To: C&C Project Management Pty Ltd  
Project: 48a Queenscliff Road, Queenscliff NSW  
Report: FIRE ENGINEERING REPORT (107347-FER-r4)  
Date: 23 September 2019  
Client Contact: Kate Gassmann  
Email: [kate.gassmann@ccprojectmanagement.com](mailto:kate.gassmann@ccprojectmanagement.com)  
From: Michael Mason  
Direct: (02) 8484 40397  
Email: [mmason@bcalogic.com.au](mailto:mmason@bcalogic.com.au)

6.1 Assumptions.....	25
6.2 Fire Engineering Analysis Methods.....	25
<b>7 PERFORMANCE SOLUTION 1 – TO ALLOW PROVISION OF SPANDREL THAT IS 400 MM ABOVE THE FLOOR SLAB ON THE GROUND LEVEL IN LIEU OF 600.....</b>	<b>27</b>

Figure 7: Location of the proposed spandrel that is 400 mm above the slab level on the ground level (ground level shown)

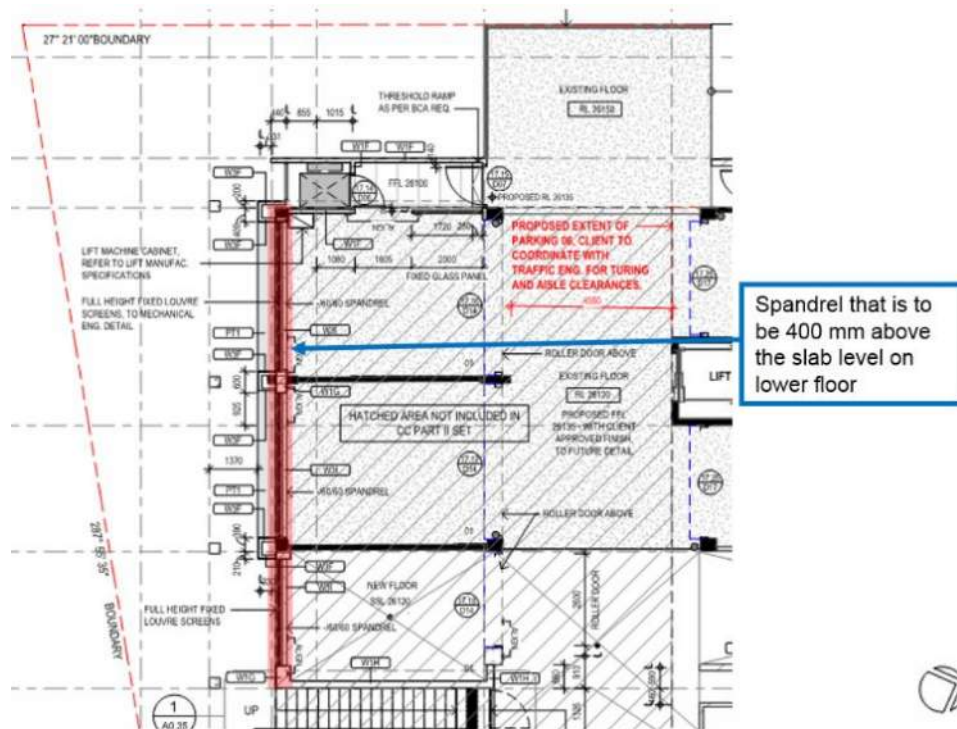
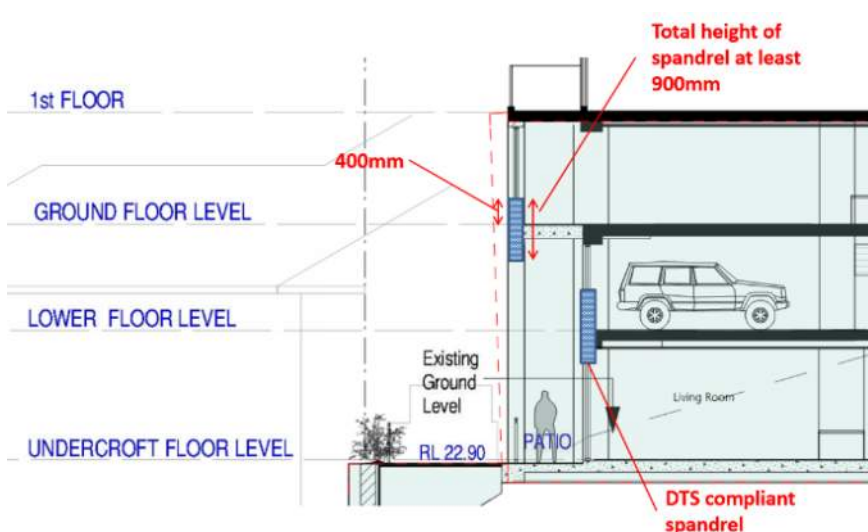
FRNSW Comment: In principle support is provided subject to all analysis inputs and assumptions being detailed in the FER and agreed upon by all relevant stakeholders, and the analysis demonstrating compliance with the Performance Requirements of the NCC.

Figure 20: Fire exit discharge

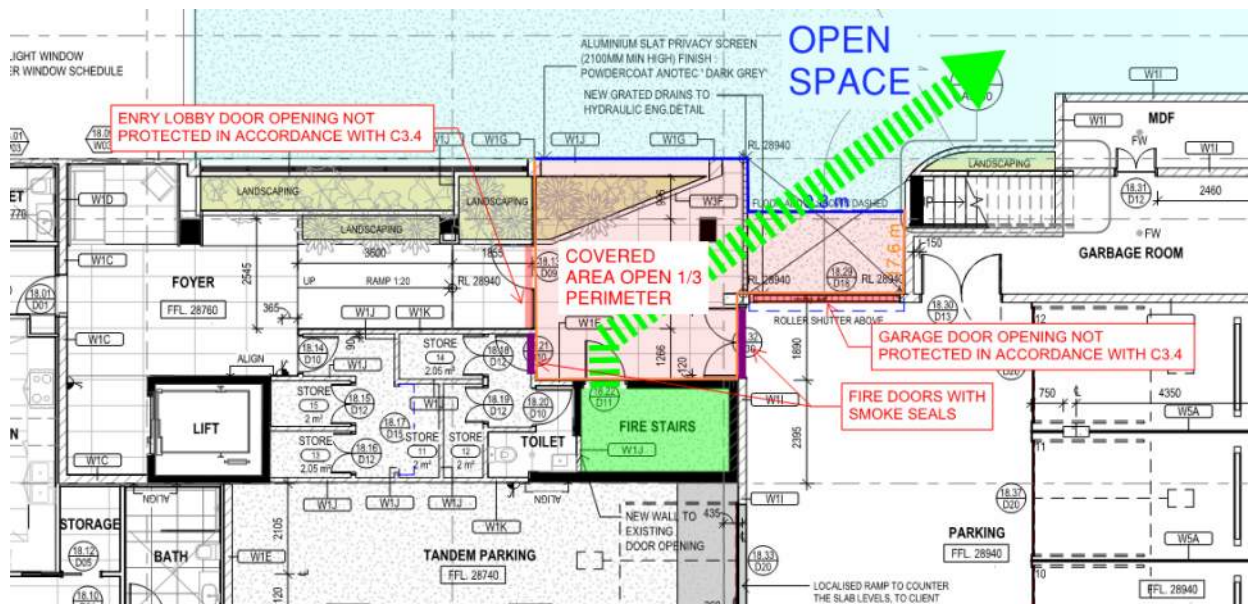
FRNSW Comment: In principle support is provided subject to the analysis in the FER demonstrating compliance with the performance requirements of the NCC.

Moreover, the building is to be provided with a smoke detection and alarm system throughout, which is expected to provide early fire alarm to the occupants at the early phase of the fire development. The subject covered discharge area is approximately 4 metre sway from the existing external ramp (driveway). The minor increase of travelling time for occupants to reach the existing external ramp (driveway) is not expected to affect the occupant evacuation.

In the unlikely event of a fire, the covered area is provided with natural ventilation for 1/3 of its perimeter which is expected to provide natural smoke ventilation provisions, consistent with provisions for a covered area outside a building envelope permitted under BCA DTS D1.7(b)(c).

**Figure 21: The proposed fire door on the lower ground level to the lift serving the new unit at the undercroft**

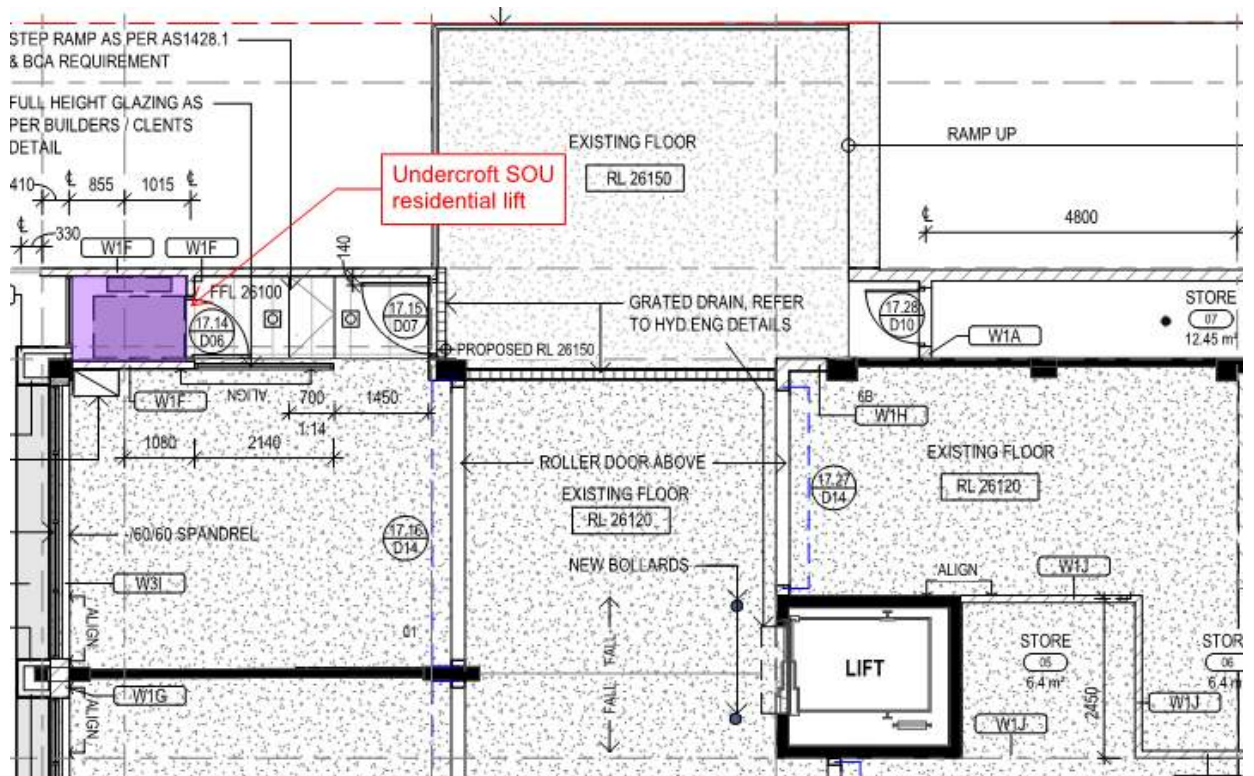
FRNSW Comment: In principle support is provided subject to the analysis in the FER demonstrating compliance with the performance requirements of the NCC.

<p>3. Lift to the undercroft unit is required to be an emergency lift (BCA E3.4) – To be addressed in the FER</p> <p>a. [KG] To be addressed by BCA Logic</p> <p>b. (SB) – We dont agree with this – this is a private lift contained wholly within a SOU. If we provide a -/60/30 fire rated door at lower level where it opens to the carpark – then the lift and shaft are deemed to be contained wholly inside the SOU.</p>
<p>7. Ramp from the lower level to have a gradient no greater than 1:8 (BCA D1.10) – To be addressed in the FER, although it is existing, new works are required to make use of the non-compliant ramps.</p> <p>a. [KG] Existing – to be addressed by BCA logic</p> <p>b. (SB) These ramps area existing and are already being used by the current building occupants for access. There is nothing in the DA conditions that require upgrade of this component, thus in our opinion not an issue that needs to be addressed in a FER – in any case – how do you justify it – it is what it is.</p>

In comparison with the DTS Solution which does not provide a private lift, the emergency service personnel is considered to be facilitated to access the unit at the undercroft.
